June 28, 2021

**Subject: Blueberry Lane
Proposed Self Storage Facility
Special Permit/Site Plan Review**

Please find this response letter to Quinn Engineering, Inc. review dated June 1, 2021. For clarity, the original comment is shown and our response is shown in italics.

SITE PLAN		DRAWN BY: JSC	
SITE ADDRESS: BLUEBERRY LANE LEICESTER, MA		CK'D BY: JDD	REV #: 1
CLIENT: JUSTIN ZUFFANTE 140 SPENCER ROAD OAKHAM, MA 01068		DATE: 4-12-21	SCALE: 1' = 20'
		PROJECT #: 21-122	DWG. NO.: S-1
333 GRANBERRY MEADOW RD CHARLTON, MA		800-759-8889 508-341-2127

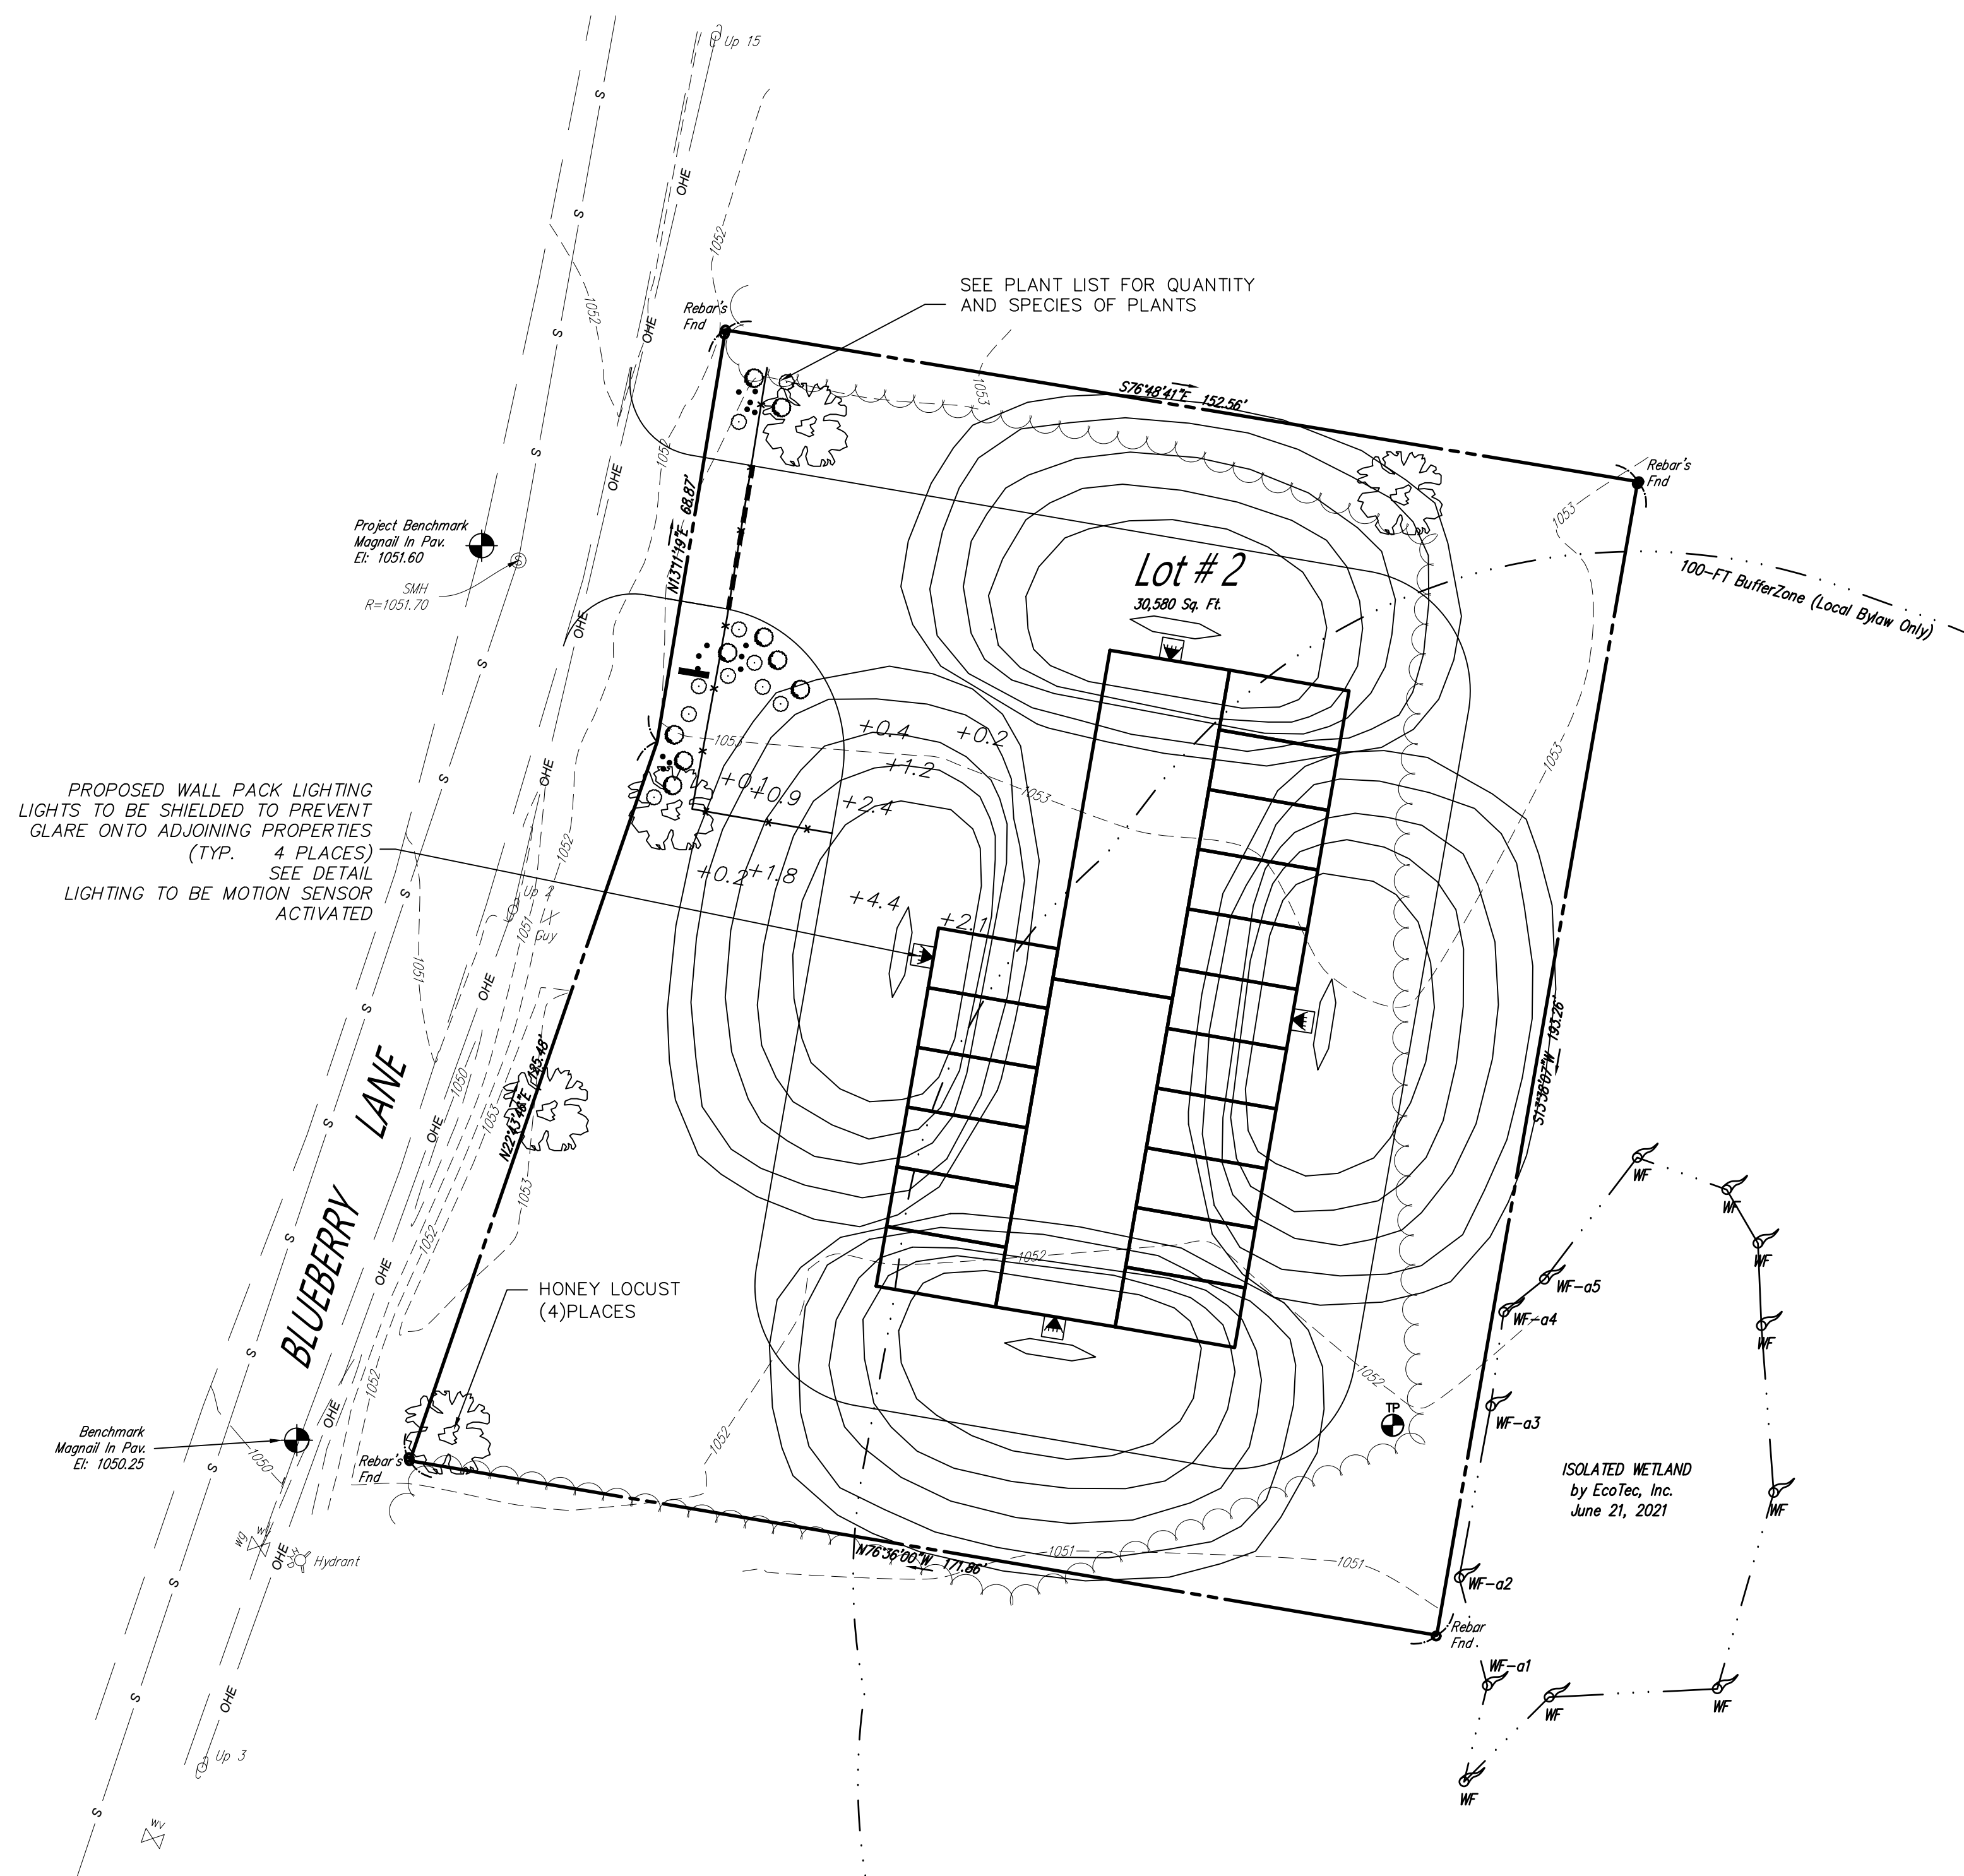
8. On Sheet S-1, the handicapped and van accessible spaces show have spot grades for elevation requirements, for clarity. *The site plan now shows spot grades for handicapped accessible spaces as well as the loading area.*

9. Pertaining to stormwater:
 - a. Plans show a test pit located in the Infiltration Basin but no record or lot of the test pit is found in the submitted information. *The test pit data is shown on the bottom left side of Sheet S-1.*

- c. On Sheet S-1, the outlet culverts are double noted, and likely to create confusion. Some of the information noted does not agree with the HydroCAD analysis. *The double note has been eliminated and the information shown on the plan should agree with the HydroCAD analysis.*

STORMWATER DETENTION AREA CROSS SECTION

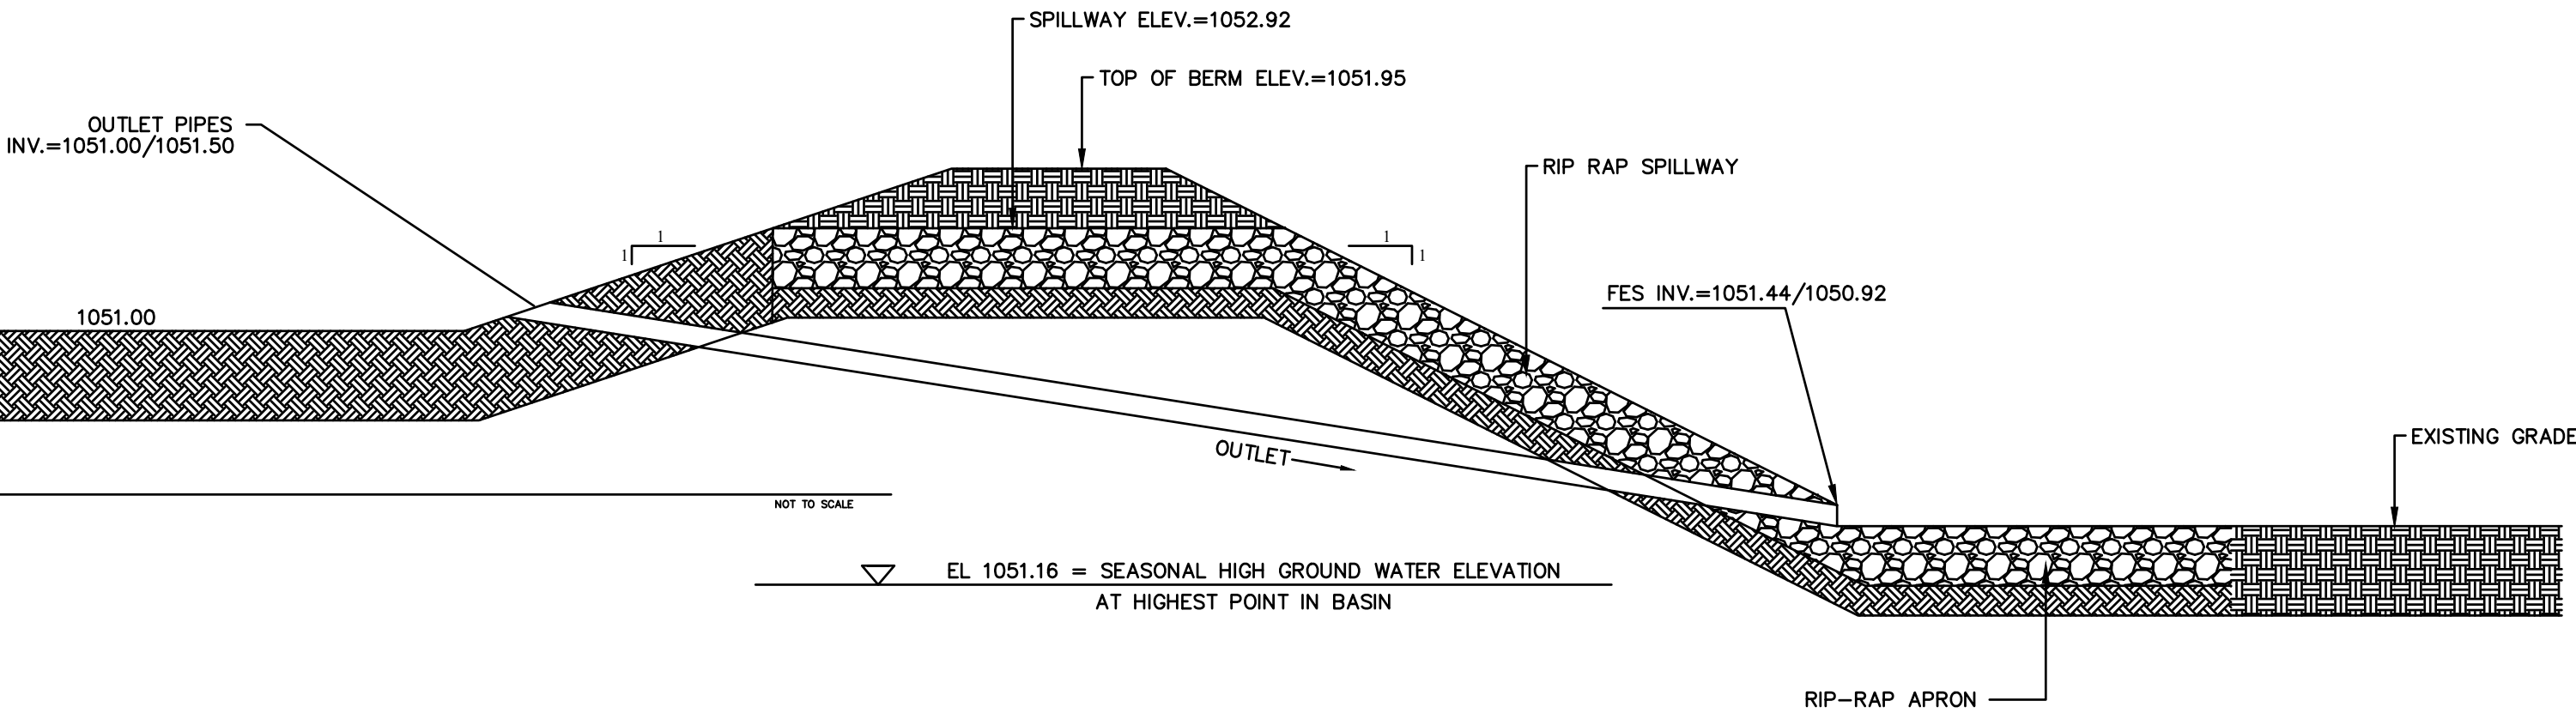
- d. Plans call for a 1:1 side slope on the detention area; the Massachusetts Stormwater Handbook recommends a maximum slope of 3:1. *The side slopes have been revised to a 3:1 slope.*
